**CITY OF LA VISTA  
8116 PARK VIEW BOULEVARD  
LA VISTA, NE 68128  
P: (402) 331-4343**

**PLANNING COMMISSION AGENDA  
AUGUST 17, 2023 – 6:30 P.M.**

**CITY OF LA VISTA  
PLANNING DIVISION  
RECOMMENDATION REPORT**

Re: Val Vista Car Wash; Traffic Impact Study Comment Response Letter

# Noise Map with Sound Mitigation Barrier

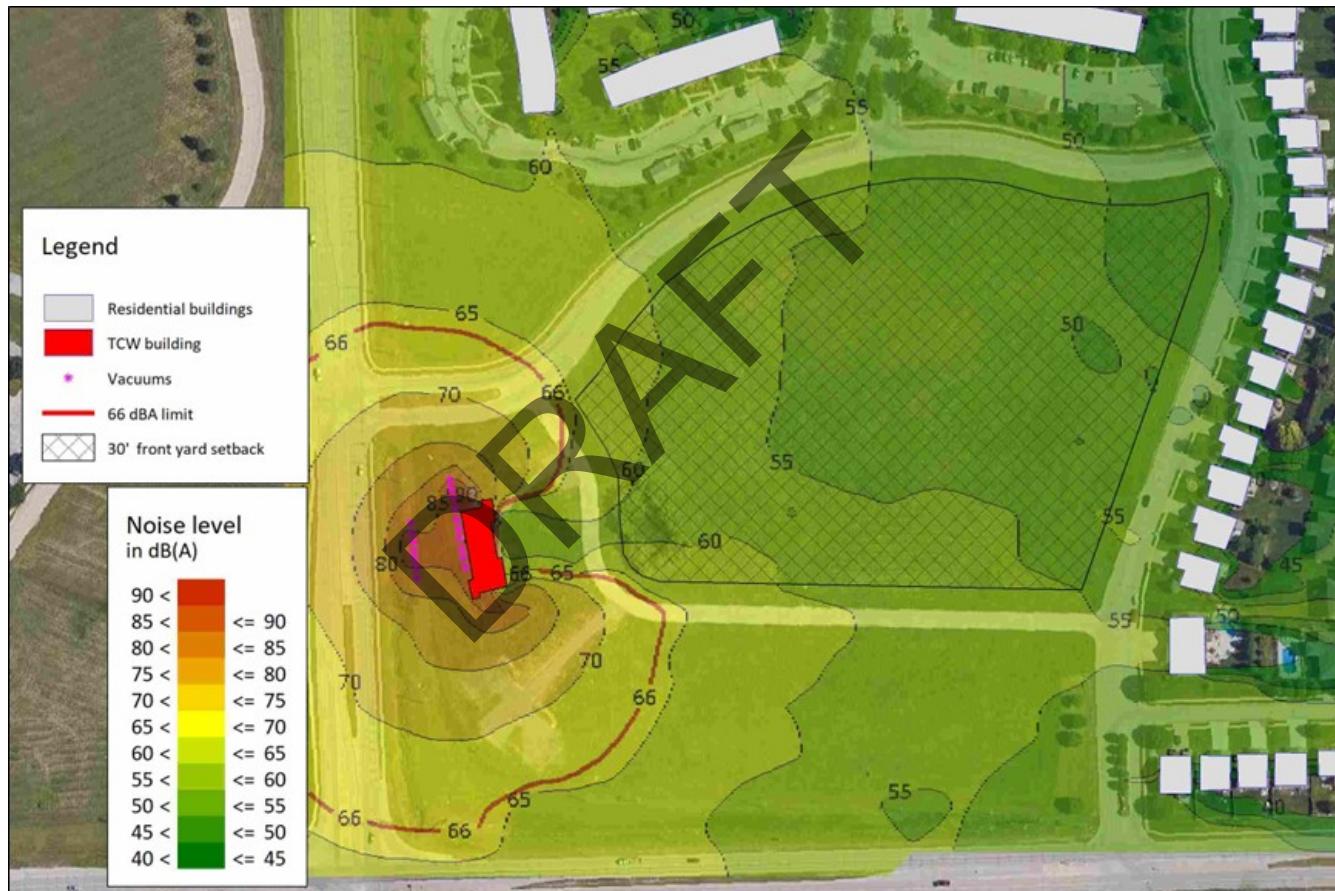
3. Pertaining to Section 6.05.06, please provide a map of the modeled existing and future noise impact that includes the subject location and surrounding properties with noise measured in terms of the hourly, A-weighted equivalent sound level in decibels (dBA).

10. The level of noise that accompanies this use as a car wash operation may be an issue for future planned residential properties to the east. The calculations for noise levels that could impact the adjacent residential buildings is above generally acceptable levels. In addition, the car wash is proposed to operate until 9:00pm.

Car Wash Vehicle Queuing Available

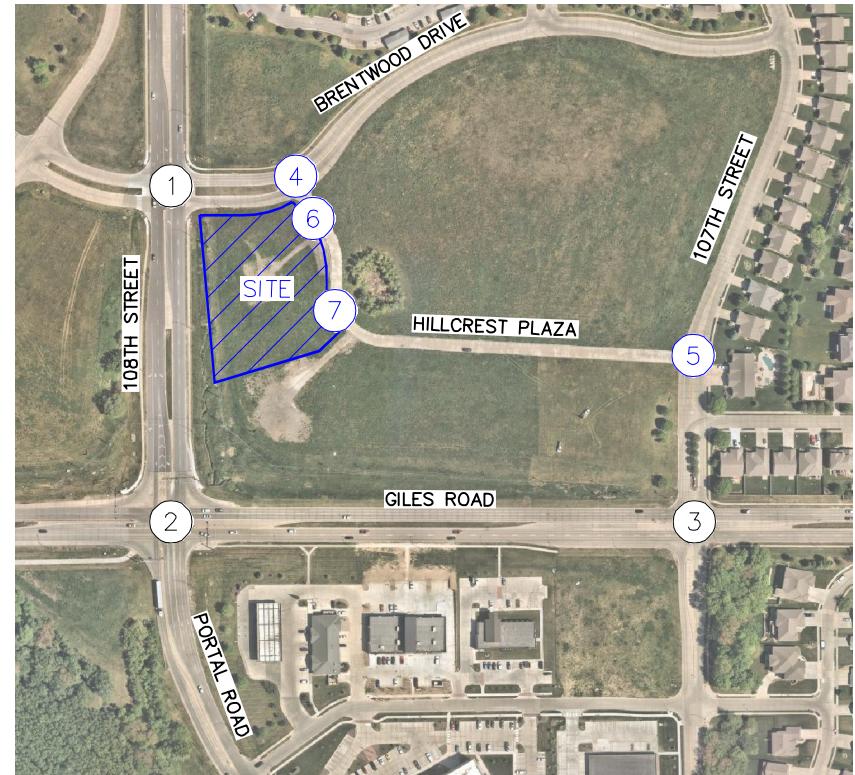
**Comment #7:** A southbound right-turn lane on Hillcrest Parkway into the Val Vista car wash should also be considered to provide added storage for entry into the north car wash and limit potential for spillback to Brentwood Drive. This would provide for vehicles destined to the Val Vista car wash and vehicles to the other car wash could then bypass queued Val Vista car wash customers. This is illustrated in the following graphic. This may require modification to the site layout to accommodate turning template into the site.

**Response:** A southbound right turn lane will be provided at the entrance access along Hillcrest Plaza.

However, if stacking ever becomes an issue and vehicles stack further past the southbound right turn lane into the site, then alternative routes will be implemented. The south access (entrance) will be closed off by temporary barricades to reroute entering vehicles to the north for vehicles to be able to stack around the south side of the building in a counterclockwise direction. A site plan snip of this temporary operation is shown below:
